Office Action Summary

10/647,155

This is the first Office Action for application number 10/647,155, Mounting System for Mounting a Support Rail to a rail of a deck, filed on 8/25/03. Claims 1-19 are pending.

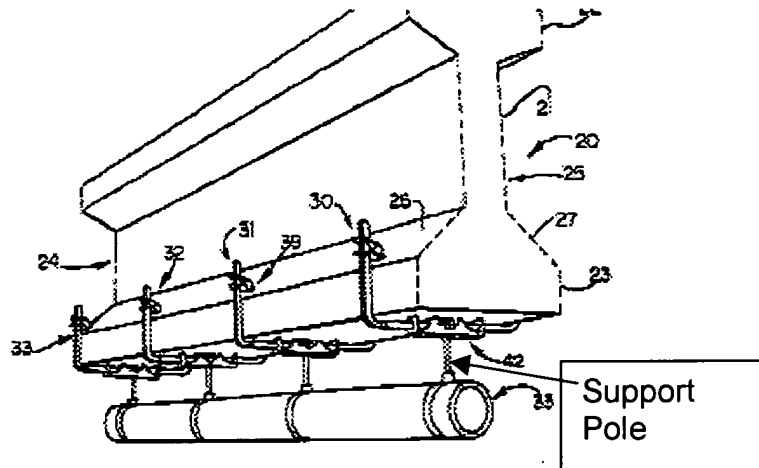
The patent to van Leeuwen et al. discloses a mounting system having a flat base structure (42) having a top side and a bottom side, two opposing elements (37, 38) extending from the bottom side of the flat base structure (42), which are positionally adjustable to create a selected distance between the opposing elements and wherein each opposing elements define a plurality of at least three stepped surfaces (54) that are generally parallel to the bottom side of the flat base structure (42) and at different distances from the base. Van Leeuwen et al. also discloses an adjustment mechanism (79) and a support pole (which is located in 82, See Drawing Below) that extends

perpendicular to the flat base structure and extends from the top surface of the base structure (42).

Van Leeuwen et al. also discloses that the flat base structure (42) defines a track (See Description in Col. 5, line 40-46) , wherein both opposing elements (37, 38) are slidably adjustable and selectively positionable within the track.
